ADDENDUM NO. 3

**For: Elementary School # 38
522 Brookewater Boulevard
Rosenberg, TX 77471
for
LAMAR CISD
3911 Avenue I
Rosenberg, TX 77471**

PREPARED BY: PFLUGER ARCHITECTS, L.P.

PROJECT NO: 24-028

14 BASE DETAIL AT INTERIOR WINDOW SCALE: N.T.S.

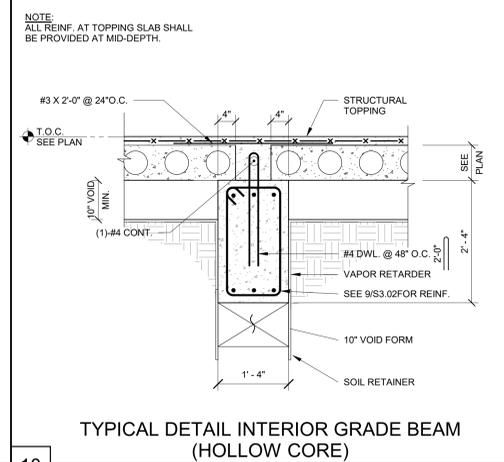
ITEM	SHEET	#	DESCRIPTION
D1-1	S3.02		Detail 14/S3.02 is added.

100% CONSTRUCTION DOCUMENTS
M2.01F
MECHANICAL 01 FLOOR
PLAN - AREA F

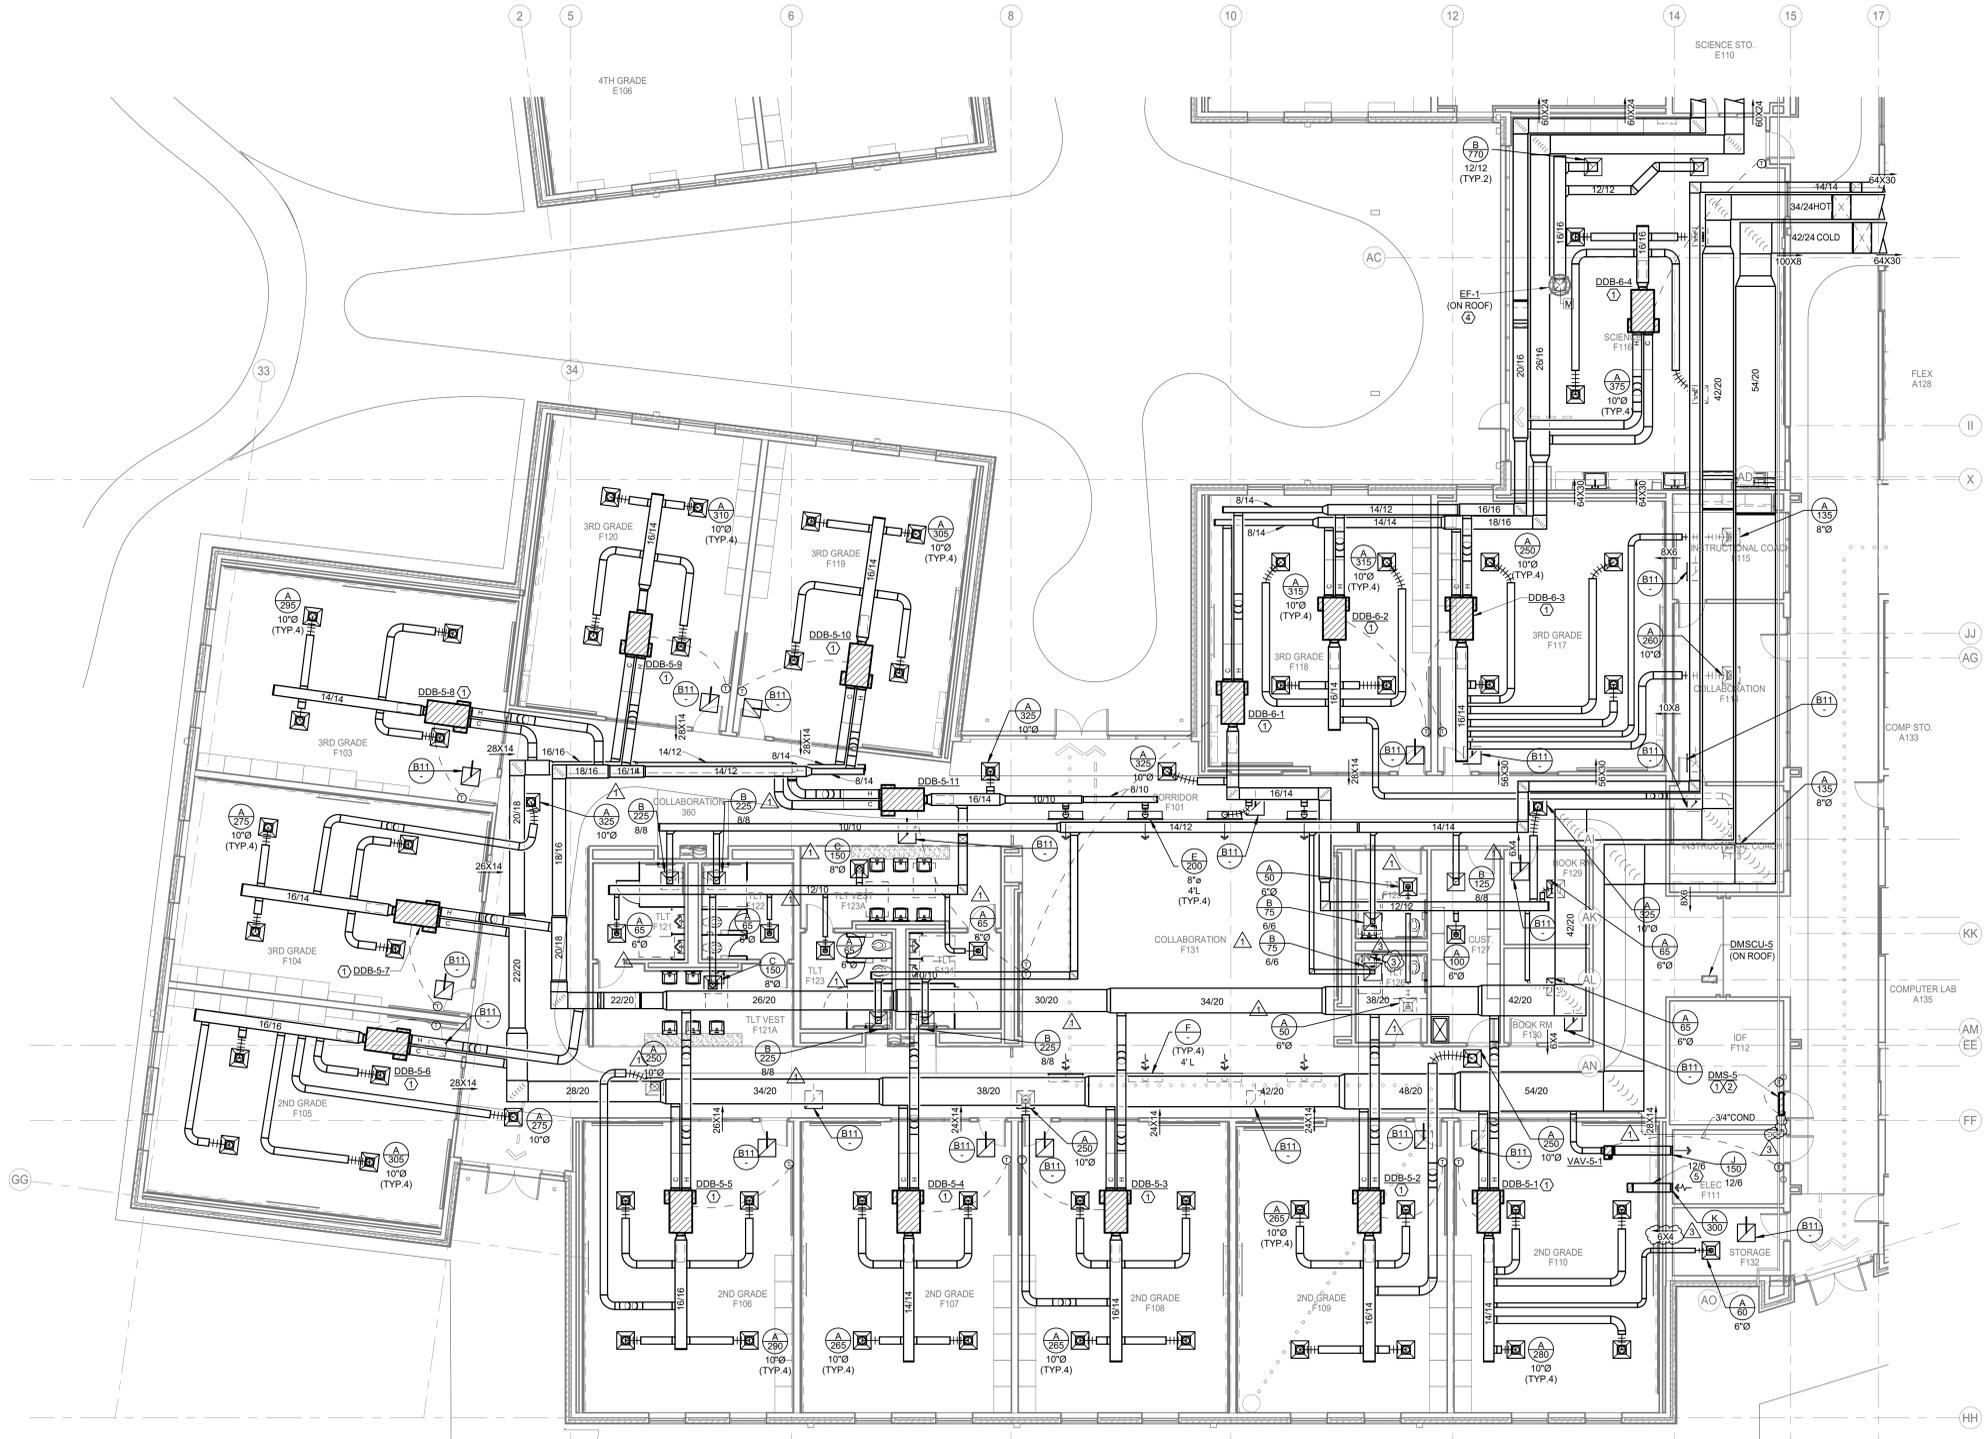
ITEM	SHEET	#	DESCRIPTION
D3-1	M2.01F		Revise condensate pipe routing for DMS-5.

D3-2	M2.01F	Storage F132, add 6x4 return air path.
D3-3	M2.01F	Replace sheet in its entirety.
D3-4	E2.01A	Library A132, revise fixture type P1-D to type P1-B.
D3-5	E2.01A	Parents Volunteer, revise fixture type P1-E to type P1-C.
D3-6	E2.01A	Revise note for fixture type M8 to the following: "...SIGNAGE PRIOR TO ORDERING. (TYPICAL OF 12)"
D3-7	E3.01D	Add keyed note 7, note shall read: "PROVIDE JUNCTION BOX FOR WALL MOUNTED CLOCKS, COORDINATE EXACT LOCATION WITH T-SERIES (TECHNOLOGY) DRAWINGS AND MAKE FINAL CONNECTION."
D3-8	E3.01D	Revise keyed note at column BE/19 to keyed note 7.
D3-9	E3.01D	Column EA/D2, add a junction box via keyed note 7 for wall mounted clock. Connect to circuit LB-61 with 2#12, 1#12G., 3/4"C.
D3-10	P4.02	Add water to fill faucets in kitchen.
D3-11	P4.03	Add water to fill faucets in kitchen and show floor drain.
D3-12	P5.01	Revise grease trap sizing calculation detail.
D3-13	T2.00	Add Card reader at mechanical yard door S007

100% CONSTRUCTION DOCUMENTS
T2.01D
TECHNOLOGY 01
FLOOR PLAN - AREA D

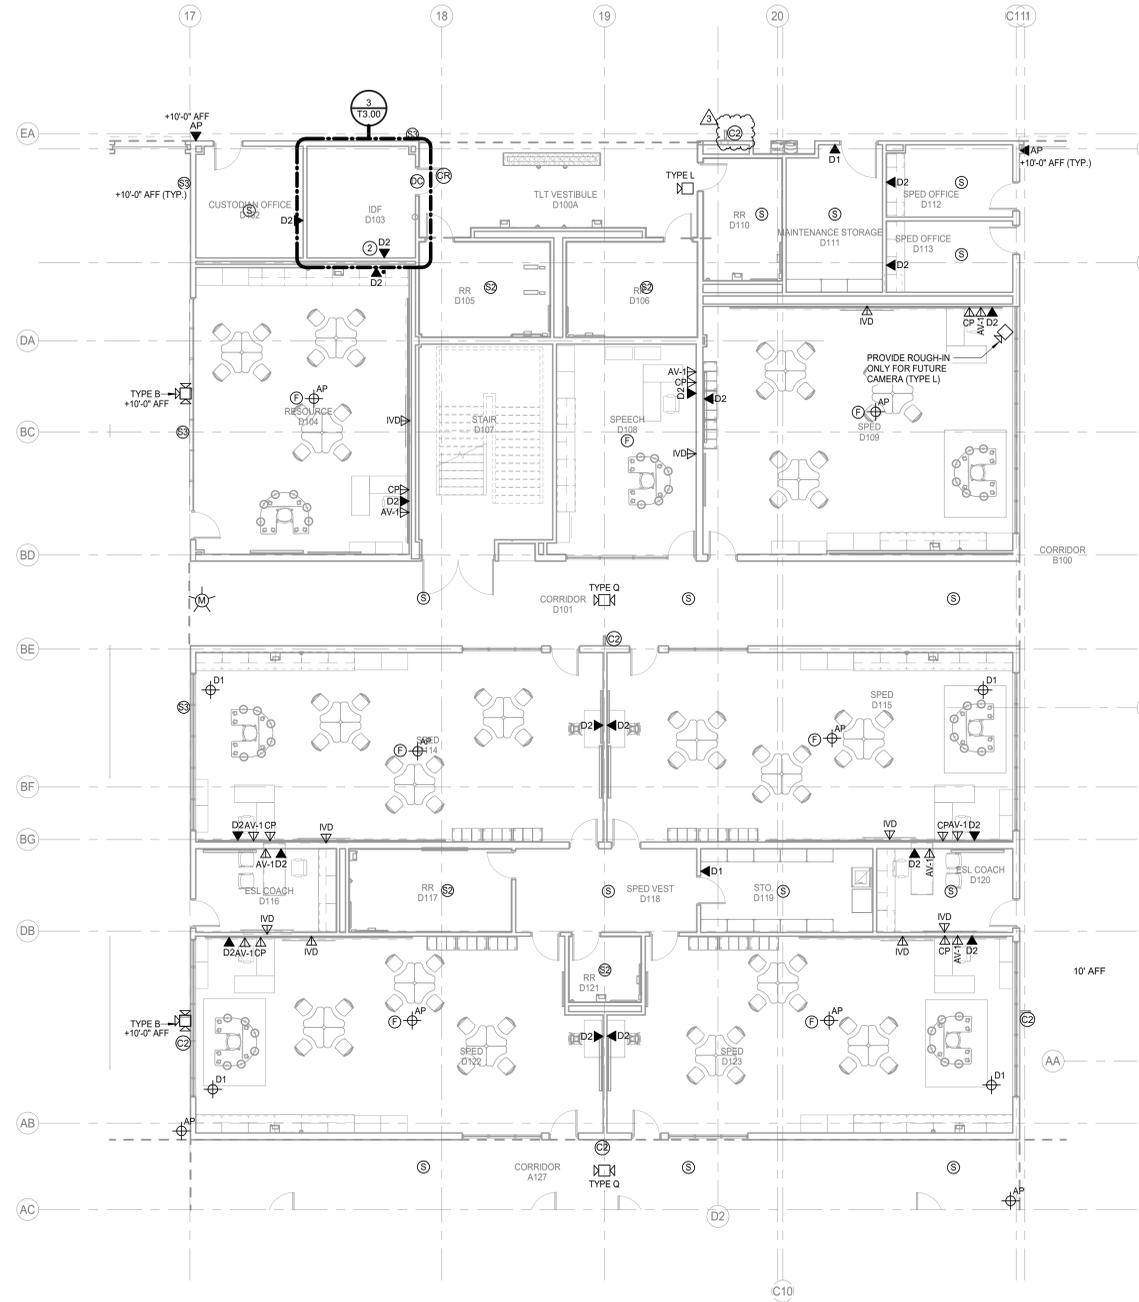
D3-14	T2.01D	Add double faced clock in corrido D100
D3-15	T4.03	Add ACS Door Connection Detail
